DIRECTIVE #2022-01

SUBJECT: FIRE HYDRANT ALUMINUM COATING

Standard Detail WTR-2

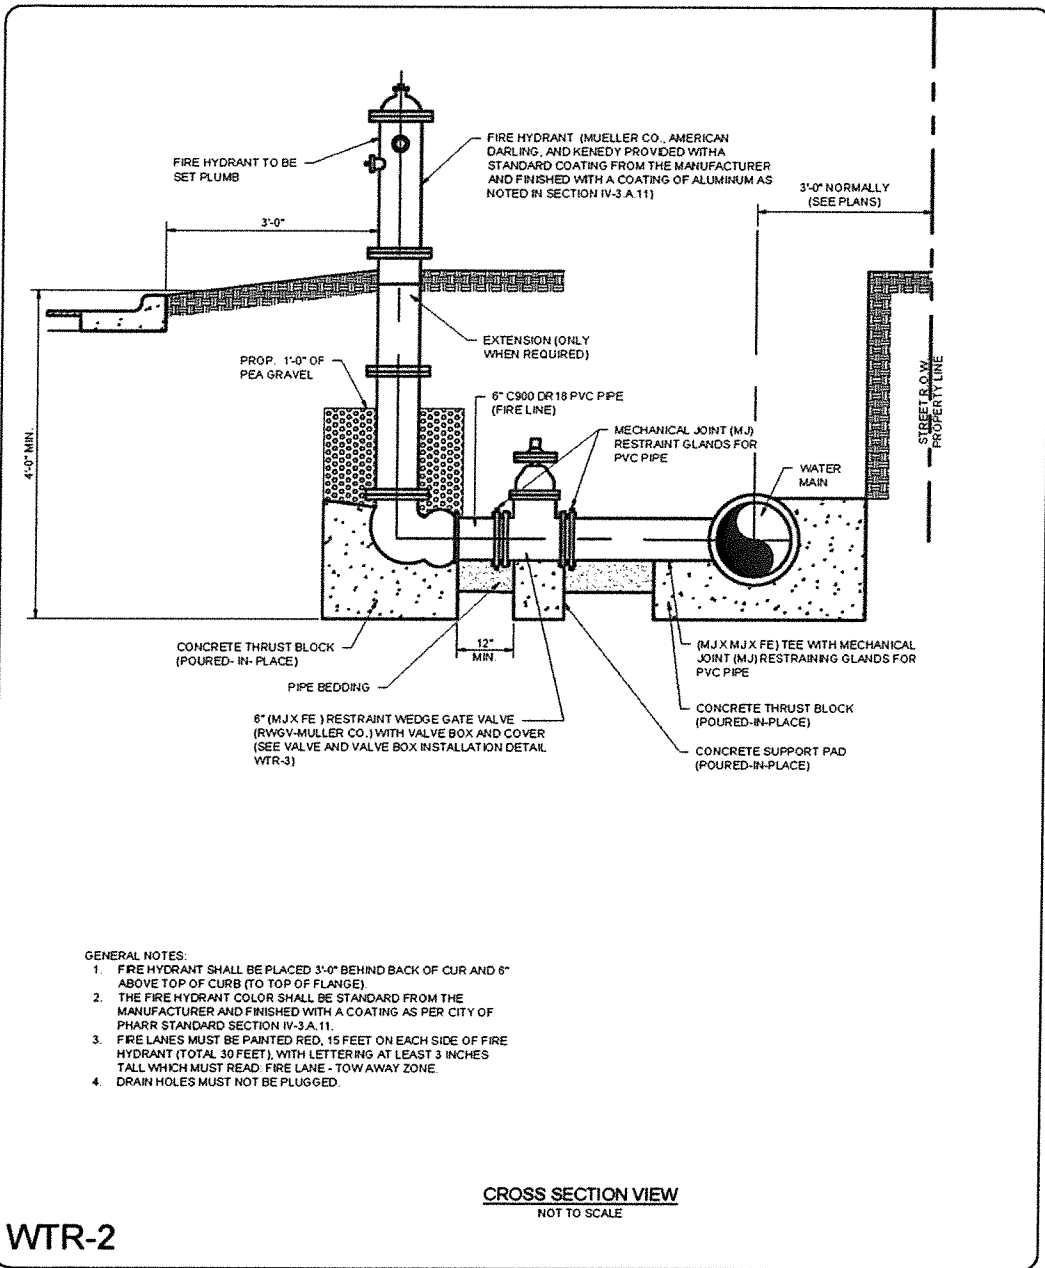
FIRE HYDRANT (MUELLER, AMERICAN DARLING AND KENNEDY)PROVIDED WITH A STANDARD COATING FROM THE MANUFACTURER AND FINISHED WITH A COATING OF ALUMINUM AS NOTED IN SECTION IV – 3.A.11 ~~PAINTED CAUTION YELLOW WITH~~)
